PD Modification Application: MM 25-0243

1.0 APPLICATION SUMMARY

Applicant: Symmes Development LLC

The subject area consists of two parcels within PD 04-0054 (as most recently modified by PRS 07-1707) and referred to as Parcel B. The PD is approved with a detailed site plan for limited CG zoning district uses, BPO zoning district uses, a mini-warehouse, and a wireless communication support structure. No changes to Parcel A are proposed.

8.2 Proposed Site Plan (Full)

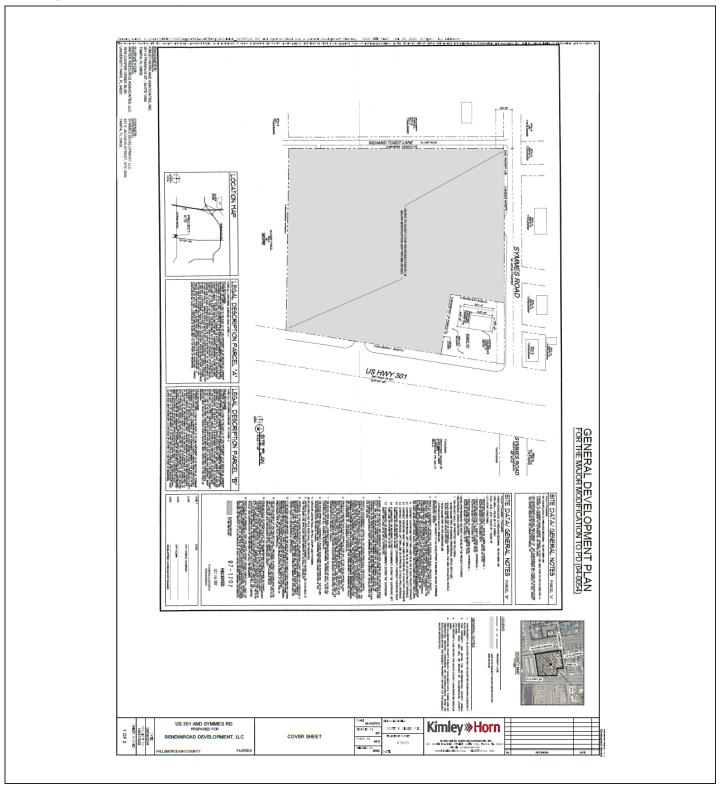
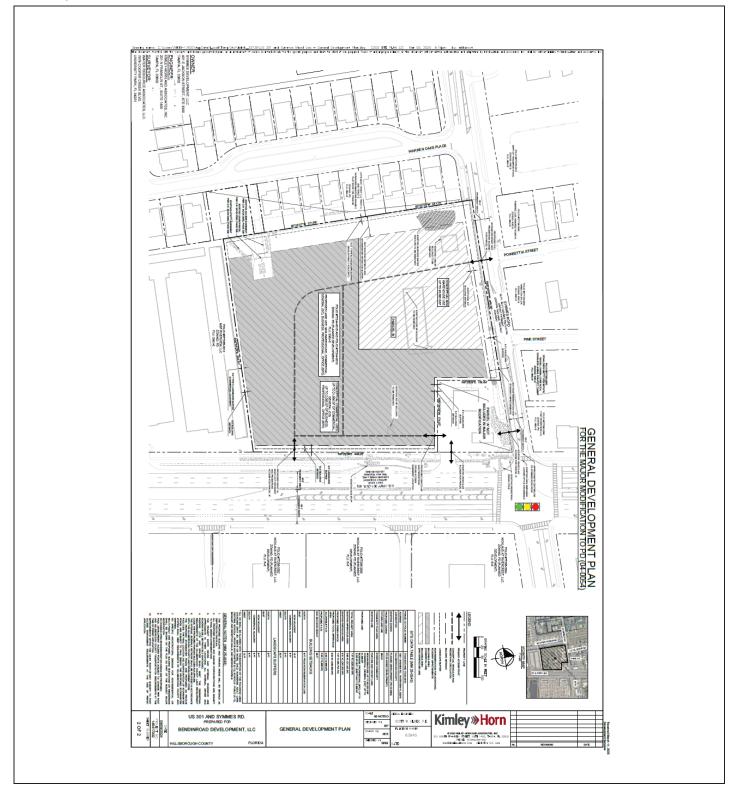
- 1. Western buffer to be corrected from 10 feet to 20 feet on the site plan.
- 2. Southern buffer to be corrected to remove Type C.
- 3. Prior to PD Site Plan Certification, the developer shall revise the Site Plan to:

- 4. Add a second footnote to the bottom of the "Site Data Table" and attribute it to the "Proposed Use" line item, the footnote for which shall state "**Subject to a trip generation cap see conditions of approval."

- 6. Add crosshatching between the Proposed Access/Cross-Access Stubout and Shared Access Facility connection and the access to US 301 and label as "with folios 77244.0005, 7244.0010 and 77244.0015".

- 7. Modify the label reading "Existing Bus Stop" to instead read "Potential Bus Bay Relocation/Conversion See Conditions of Approval".
- 8. Revise the site plan to relocate the 8-foot landscape buffer along Symmes Rd. such that it is located outside of the "48-foot Right-of-Way Dedication/Preservation Area".

- 9. Modify the label reading "48-foot ROW Reservation for Roadway Improvements" to instead read "Up to 48-foot Right-of-Way Dedication/Preservation (per Hillsborough County Corridor Preservation Plan) Area See Conditions of Approval".

- 10. Revise the site plan to show proposed substandard road and site access improvements along Symmes Rd. and label accordingly.
- 11. Delete General Notes 3 and 9. Staff notes that there is likely no intent to construct internal roadways (which must comply with TTM requirements for TS-3 roadways), only internal driveways. Regardless, staff notes that single dashed are already indicated to be conceptual in the legend. Also, only minor deviations are permitted at the time of plat/site/construction plan review without a zoning modification.

FIGURE 1 ACCESS IMPROVEMENTS

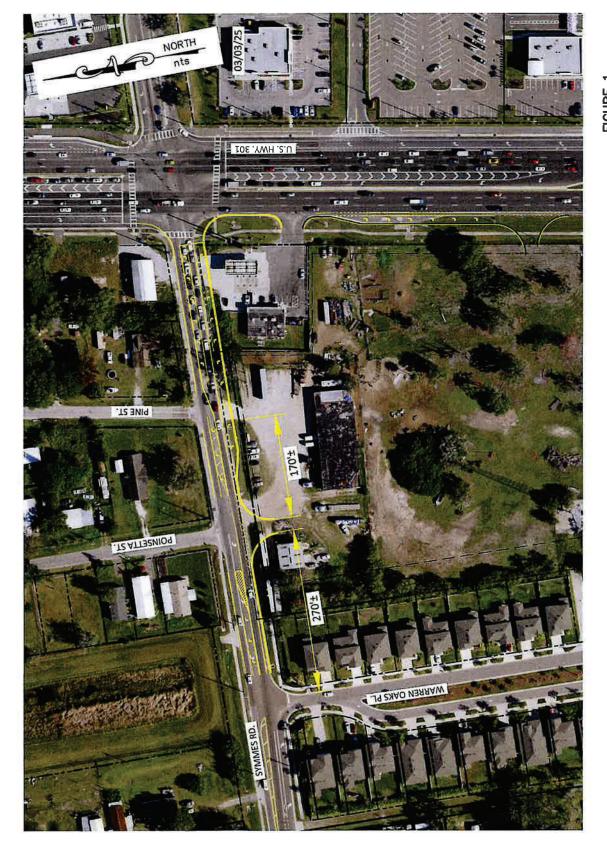
The request is for an Administrative Variance to Section 6.04.07 of the Hillsborough County LDC for the access spacing on Symmes Road. Based on Section 6.04.07, the access spacing on Symmes Road is 245 feet and the distance from the driveway to Pine Street is 170 feet. This is graphically shown in Figure 1.

In conjunction with the development of the project, the developer has committed to provide a westbound left turn lane into the project and also add an eastbound right turn at the intersection of Symmes Road and US 301. This is graphically shown in Figure 1.
